DEVIATION REQUEST AND DECISION FORM

Project Name : SF1819: Lorson Ranch East Filing 2

A deviation from the standards of or in Section **El Paso County Standard Drawing of the Engineering Criteria Manual (ECM) Detail SD 4-20**, is requested.

Exhibit showing Chemical
Grout Locations on Lorson
Ranch East Filing 2

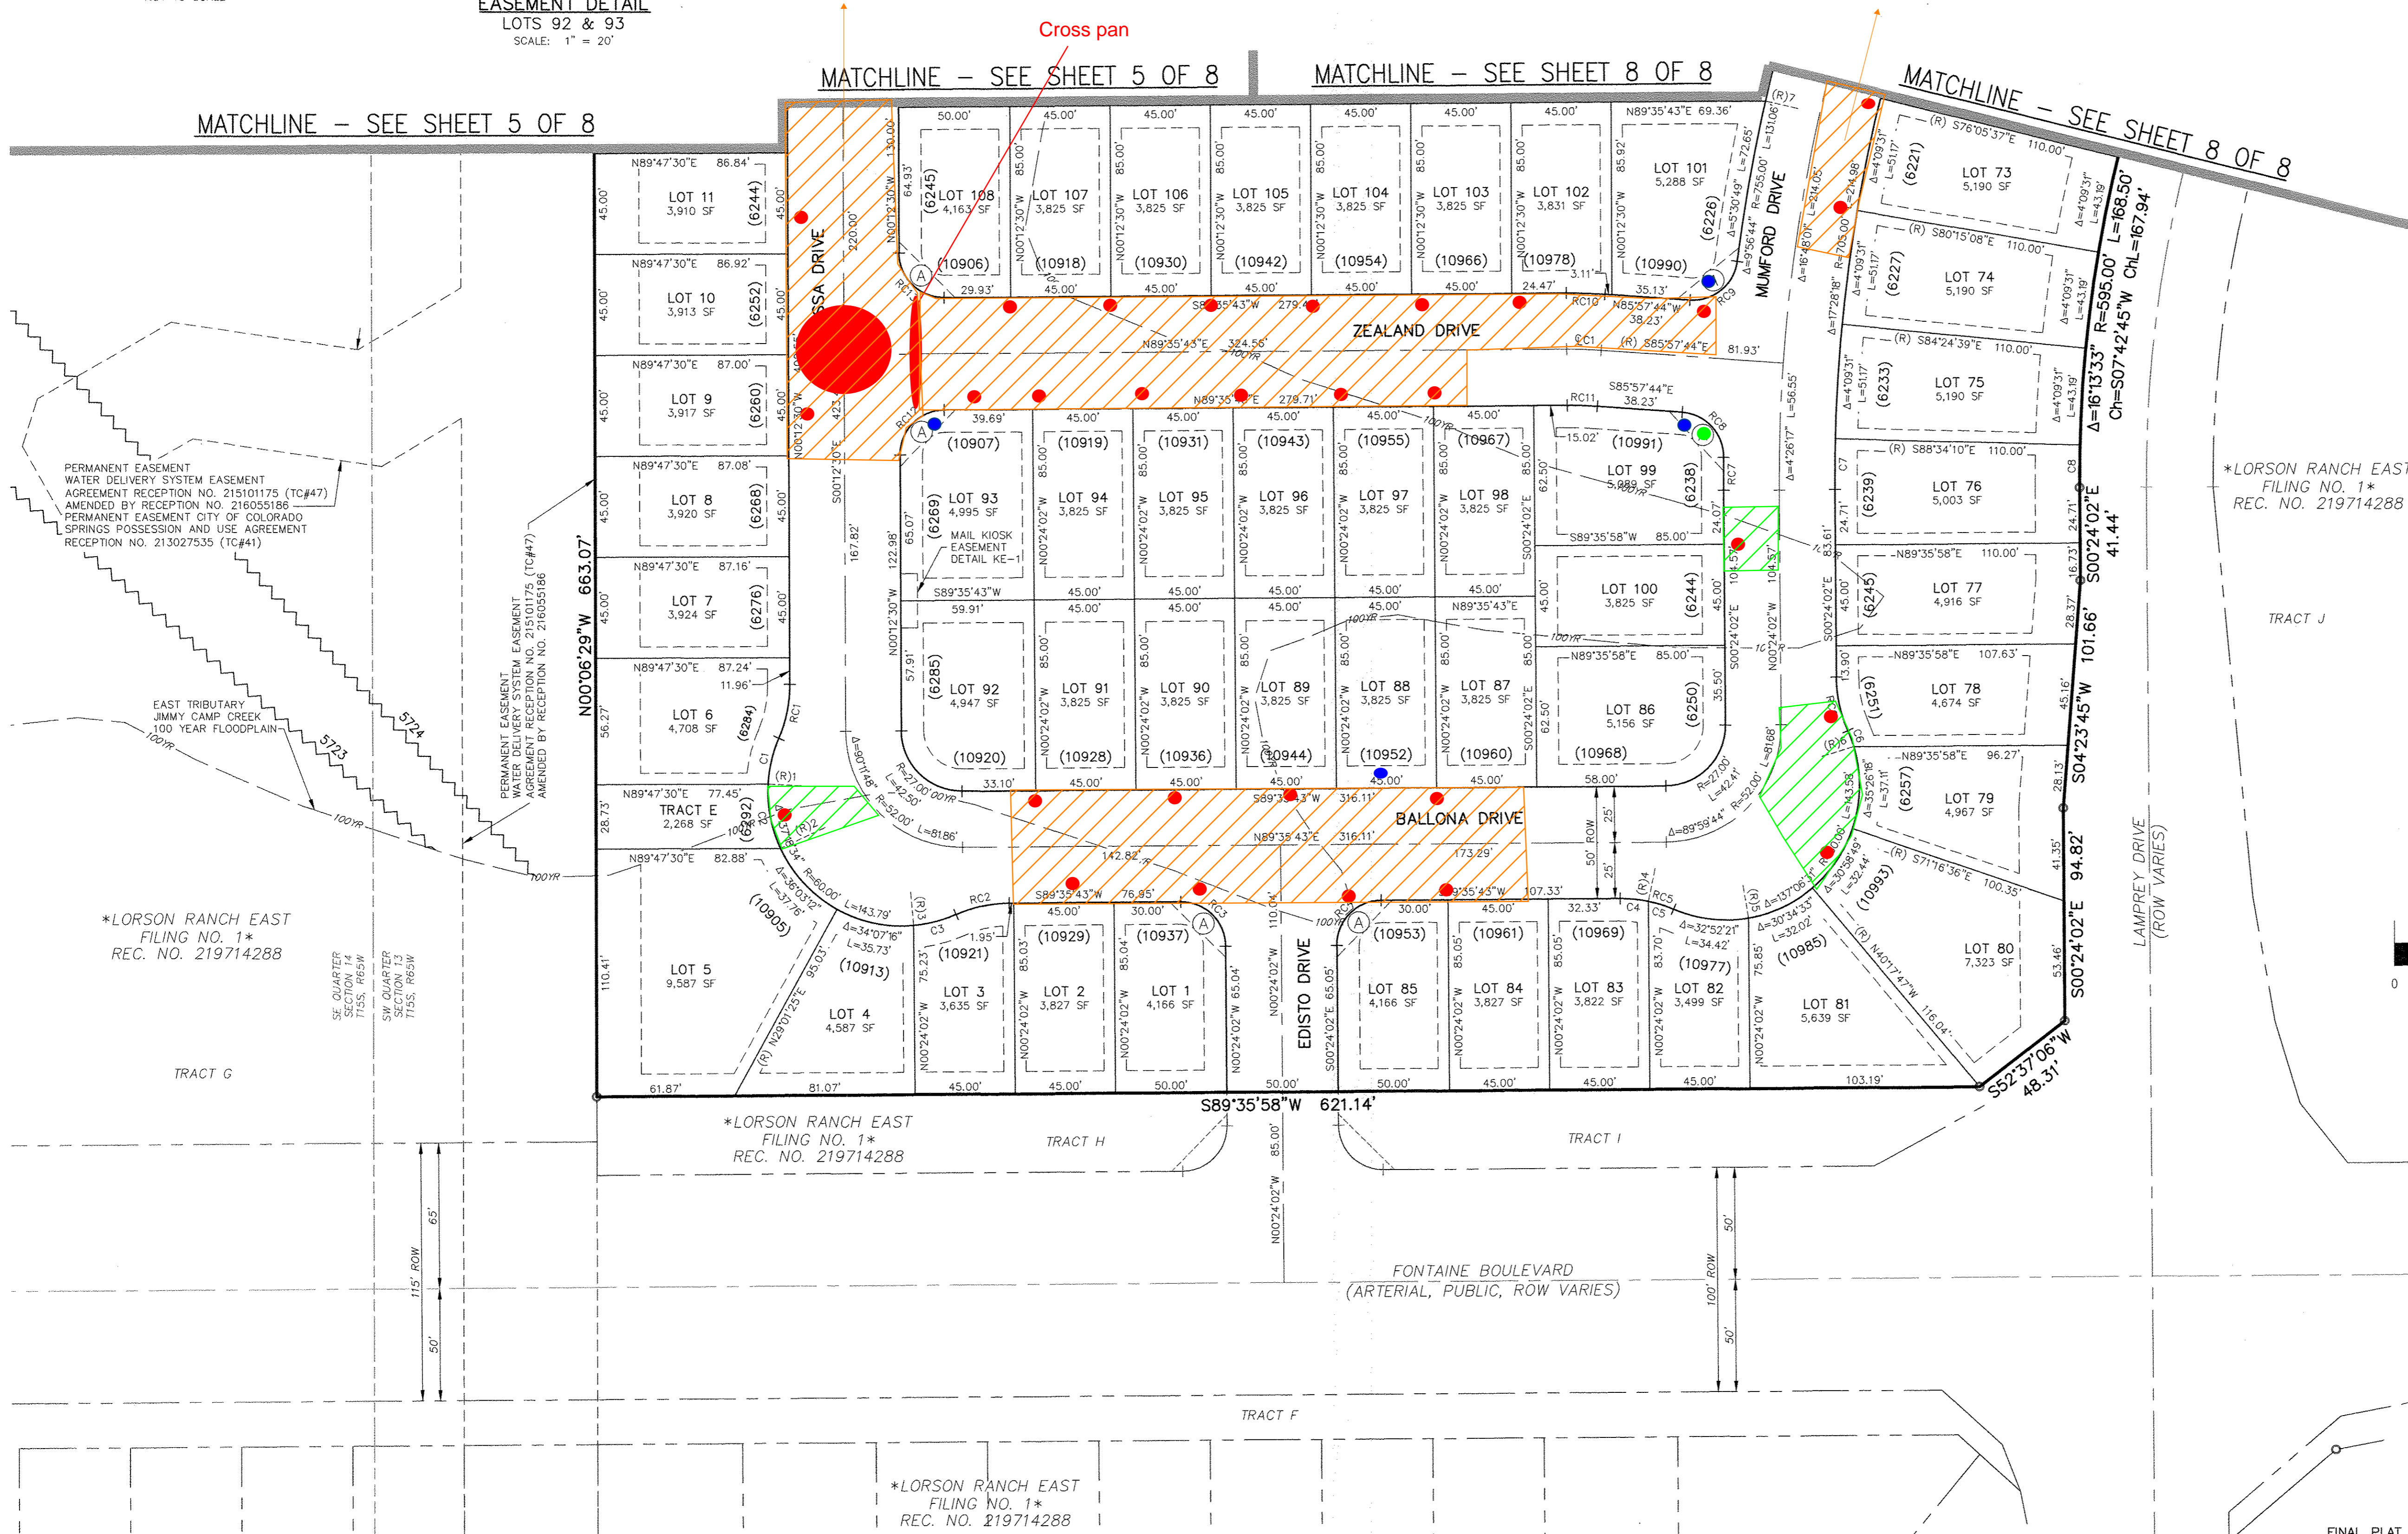
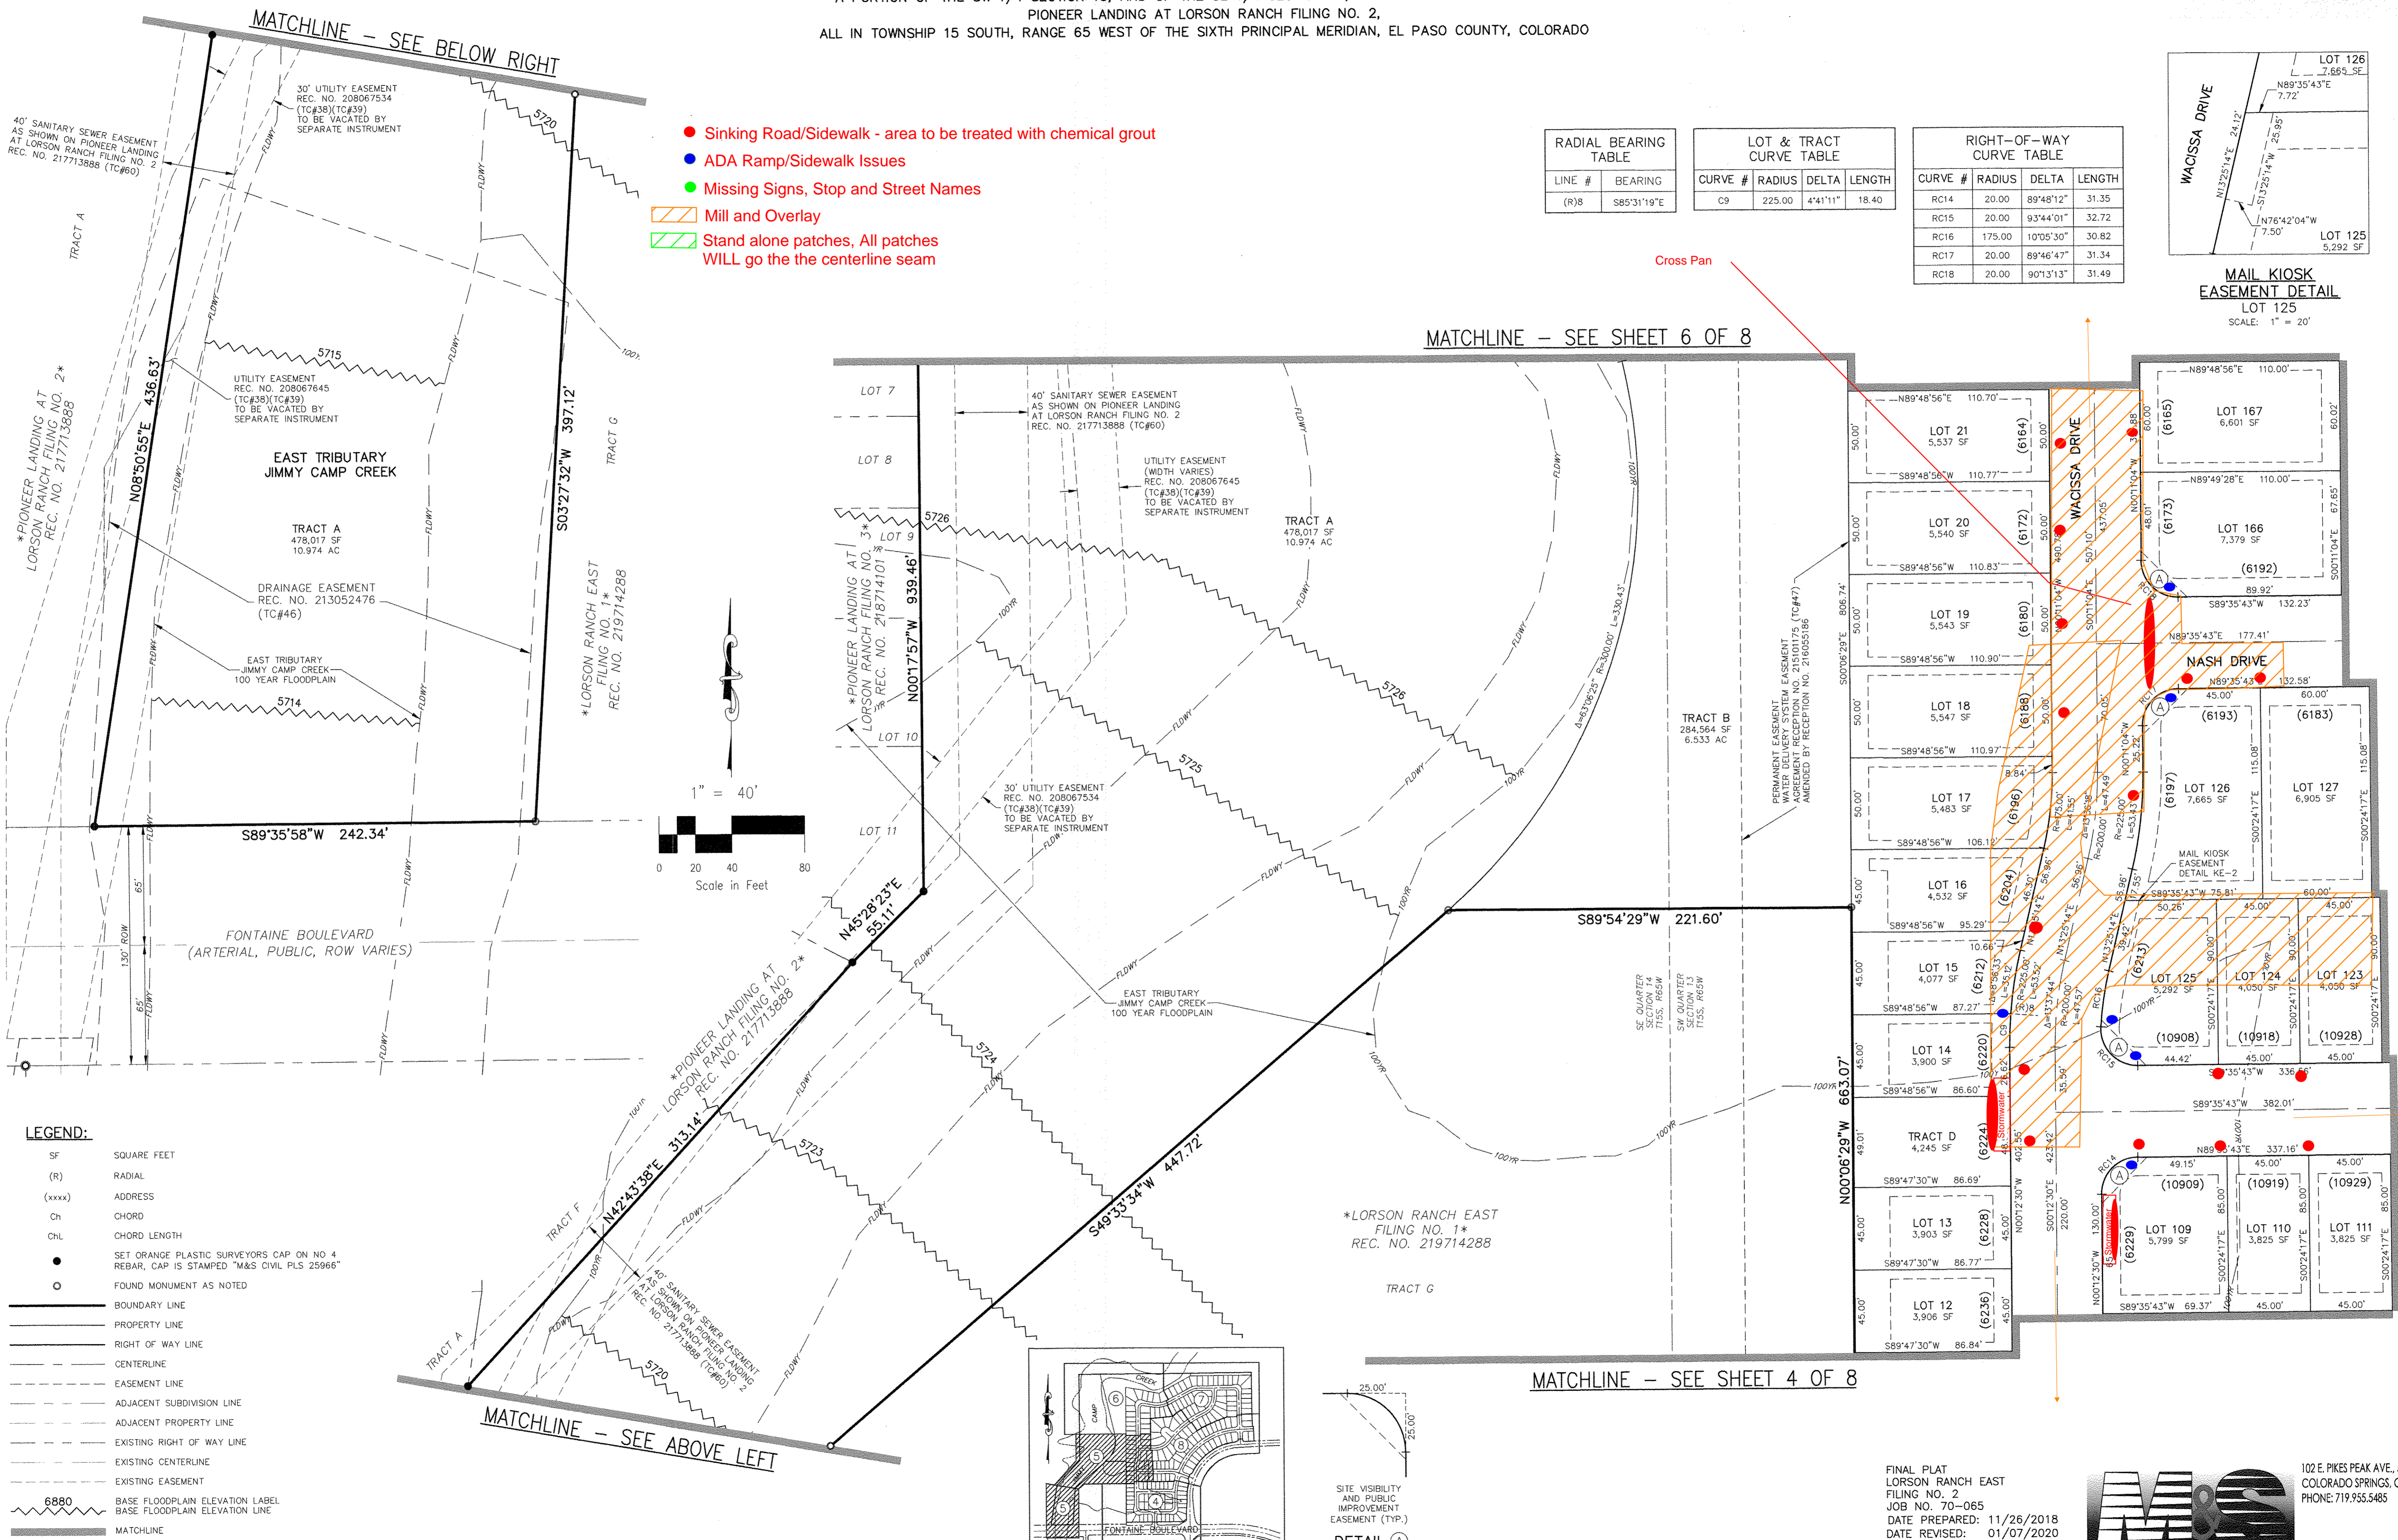
Deviation request for the use of the chemical grout to stabilize the soils within the roadway and utility trenches where settlement and distress were observed and to lift and relevel pavement, concrete flatwork, and stormwater catch basins. The deviation request is requested for Lorson Ranch East Filing 2 (File# SF1819)

The chemical grout should initially be injected approximately 4 feet on center within the utility trenches through a 1/2" injection rod advanced to a depth no greater than 4 feet below land surface (bls) through 5/8" diameter drilled holes. After an initial stabilizing injection volume that will be determined on a case-by-case basis, the injection rod tip will be raised to approximately 1.5' to 2' bls or within 0' to 1' ft bls of the base of the cement-treated subgrade (CTS) to lift and relevel the concrete slabs or pavement. When being utilized to relevel installed stormwater vaults, concrete sidewalks, or concrete curbs, the material will be injected directly beneath the concrete. The elevations of the pavement/slabs should be monitored continuously during the chemical grouting process.

please discuss whether roadway load capacity is impacted or still met by the use of this product.

Additionally, address the lifespan of the product and provide the specific product information for the proposed products listed above.

lastly, please provide the details of the 2-year warranty. What does it cover, who are the contacts should issues occur. Is there a contract # that is to be referred to if calling on the warranty is needed etc.

FYI. The following conditions of approval will be added by staff upon approval:
-As-Built drawings shall show the locations where the chemical grout was applied.
-A Notice to Proceed from EPC is required prior to the installation of the chemical grout.
-EPC inspections staff shall be present at each application of the chemical grout.
-Work a ROW permit shall be obtained for each subdivision that is currently in Preliminary Acceptance.
-An amended SIA with updated surety is required for subdivisions seeking Preliminary Acceptance.
